Permit Number: 080932

has permission to Replacement windows, exterior & site alterations

AT 98 CLARK ST

Re: Exterior and Site Alterations; 98 Clark Street

PLAN OF ENTRY STEPS

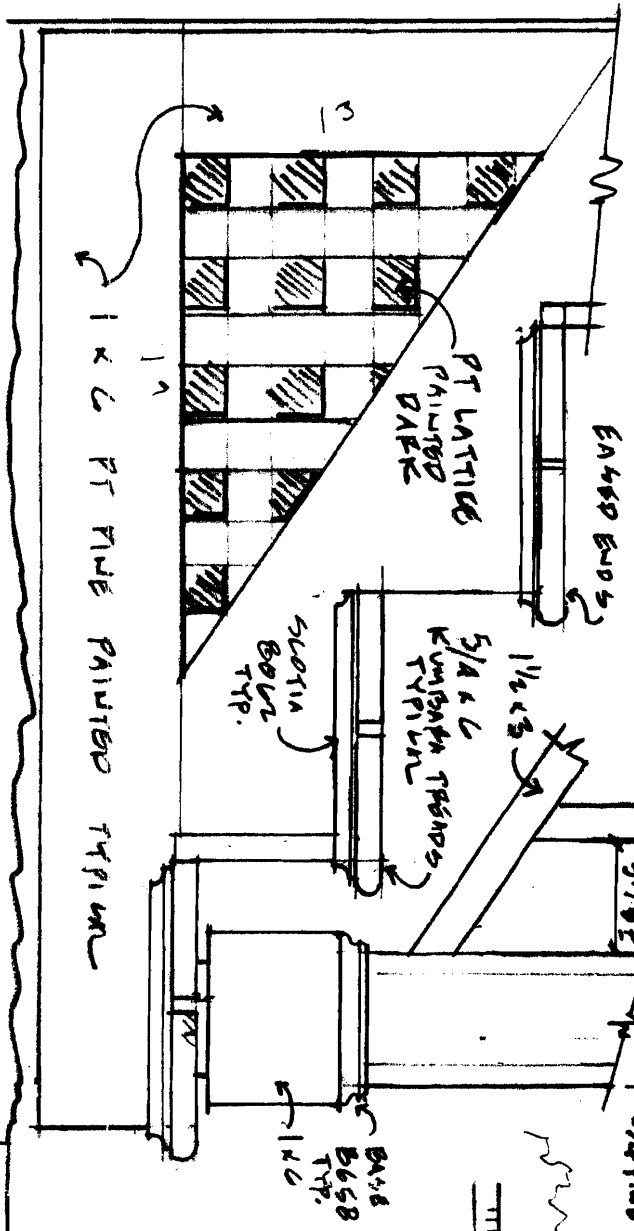
- 1) This permit is being issued with the condition that the front steps will be built within the existing footprint.
- 2) ANY exterior work requires a separate review and approval thru Historic Preservation. This property is located within an Historic District.
- 3) This property shall remain a two family dwelling. Any change of use shall require a separate permit application for review and approval.
- 4) This permit is being approved on the basis of plans submitted. Any deviations shall require a separate approval before starting that work.

8/12/2008-amachado: Left message for Lydia. Need to know if front stairs are being rebuilt within the existing footprint.

8/12/2008-amachado: Received voicemail from Lydia confirming that the front steps will be within the existing footprint.
